# East Fiber Loop Addendum 1

Updated 4/16/25

The following is an addendum to the original East Fiber Loop Scope of Work based on questions asked in the walk through on 4/8/25 and questions received in email prior to the deadline posted in the RFP.

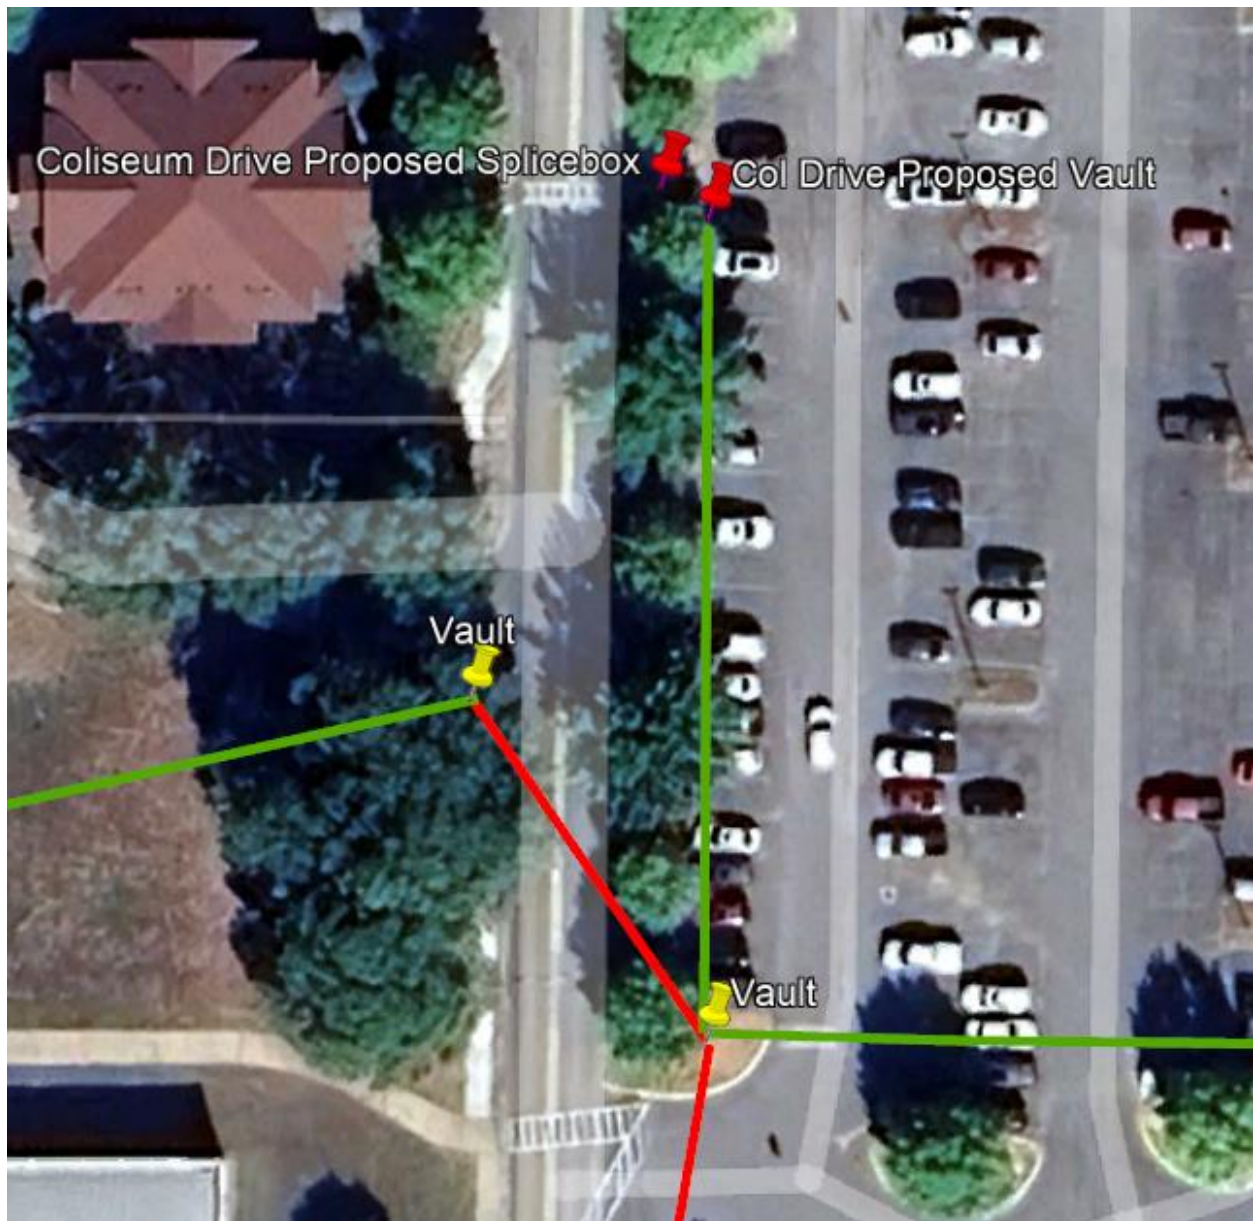
Is the bore from the existing vault on the West side of Coliseum Drive to the new vault on the East side of the road part of the required work or the optional work? Is this the proper path or could the bore go between the two existing vaults?

The bore in question is the red line at the top of the image.

The bore asked about is shown in Figure 3 of the Scope of Work in the Required Work section and should be considered part of the required work for the base project (that is the parts of the project to be done regardless of what optional parts are chosen to be implemented by ATU based on available budget). For easy reference, the figure in question is shown here:

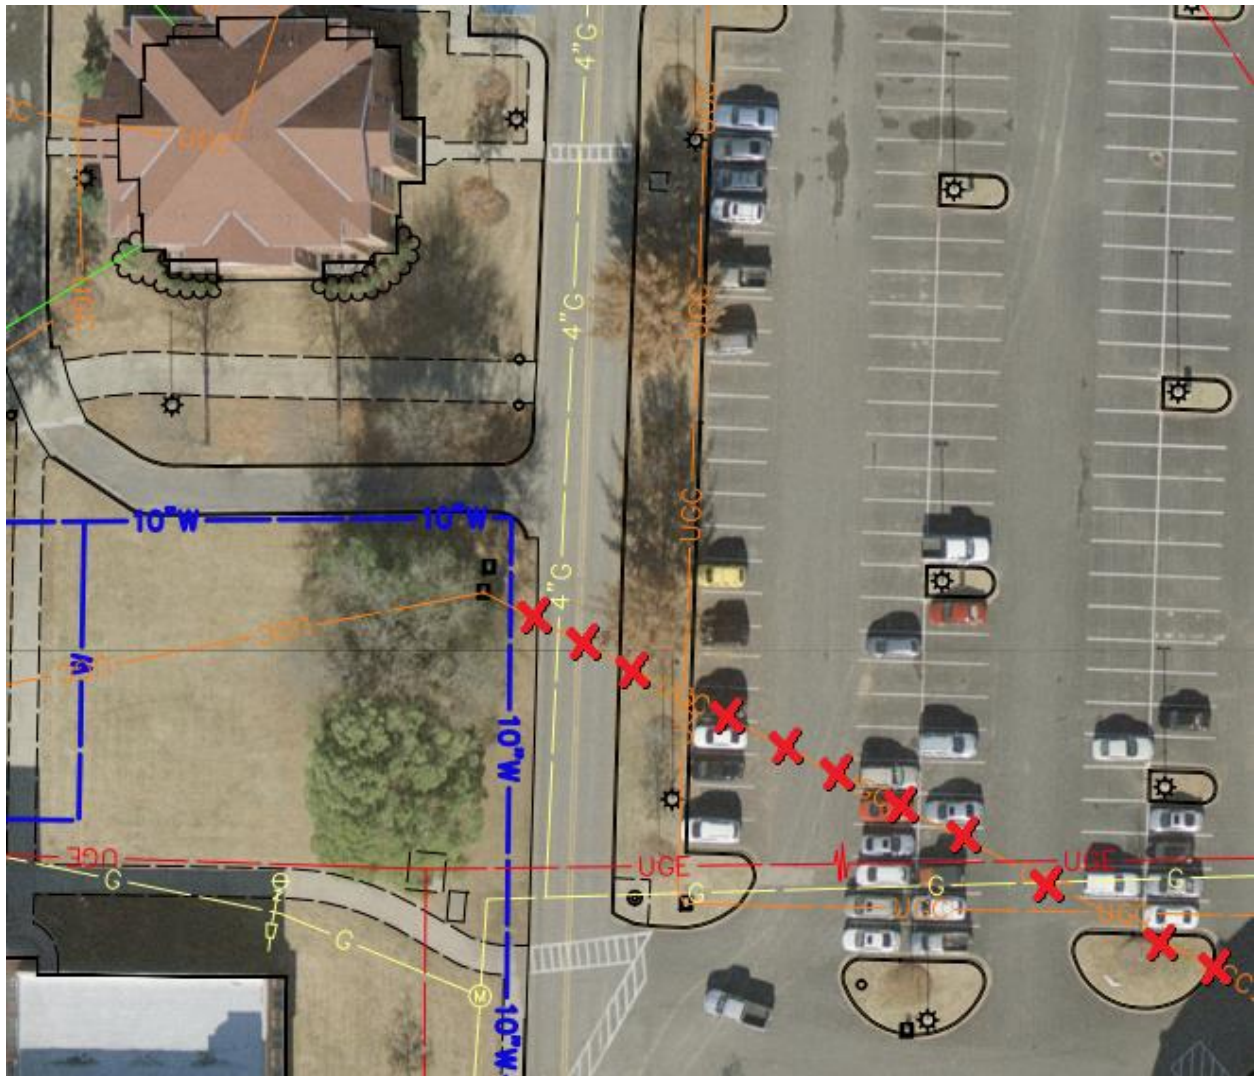
The second part of the question is about which vaults the bore path would connect to. In the above drawing, the bore connects an existing ground vault on the West side of the road (marked with a yellow pin) to a new ground vault to the Northeast on the opposite side of the road (marked with a red pin). The question was if the bore path could instead connect the existing vault on the West side of the road to another existing vault on the opposite side of the road to the Southeast. The following image shows what that could look like:

This is an acceptable alternative assuming there is a cost savings (bearing in mind if Option B is chosen, fiber would then be run in this new path and would require an extra few hundred feet of length to go South first before crossing the road) or improves the ease of the bore in some way.

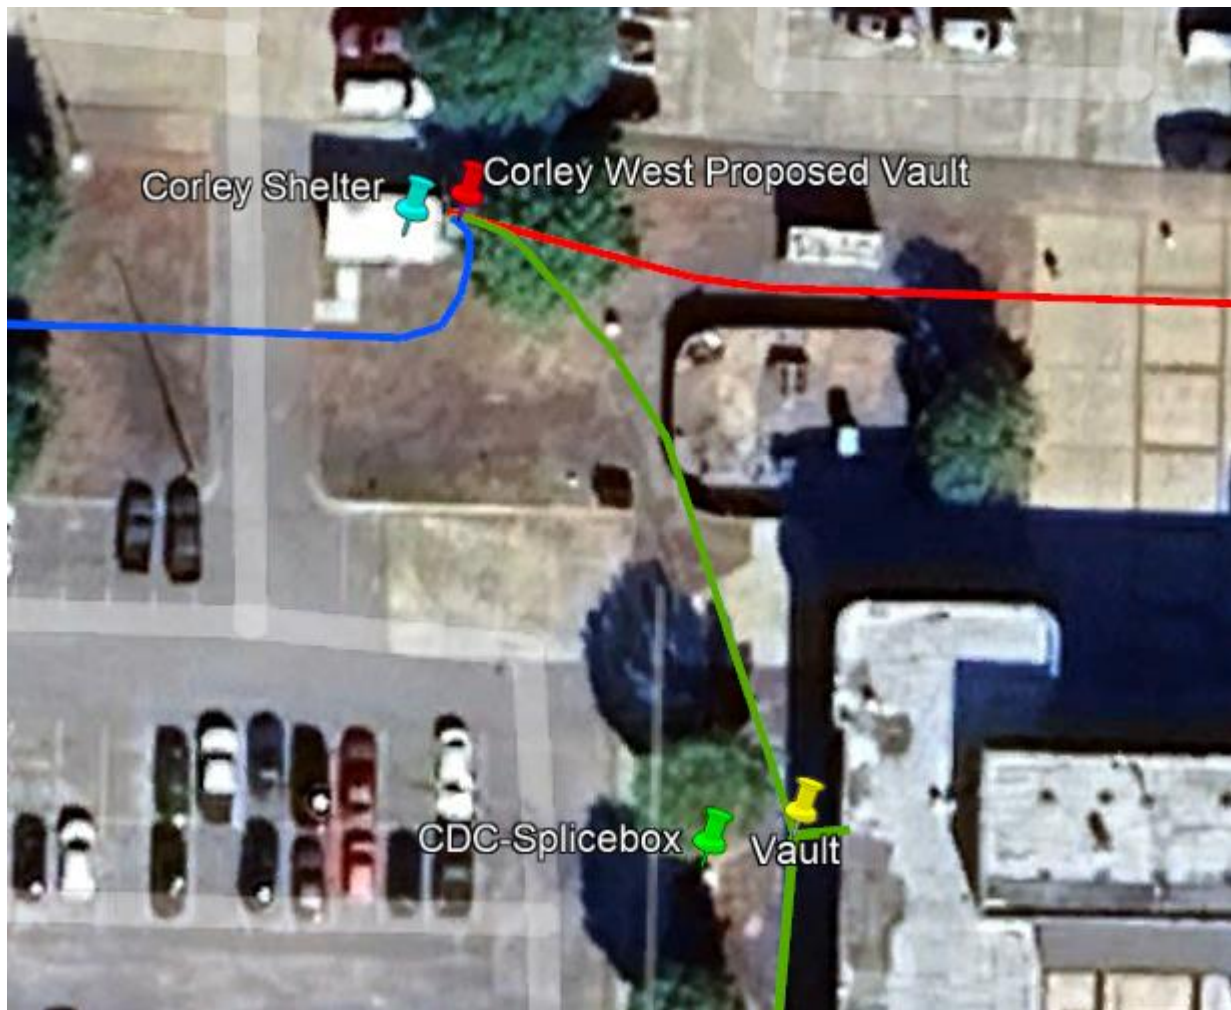
The other considerations are nearby gas and electrical utilities. The following image is an old map but much of this infrastructure may still be in place:

The X'd out orange line already crossing the street from the existing vault on the West side of the road is in an unknown condition, size, and location/path and was not included to re-use in this project.
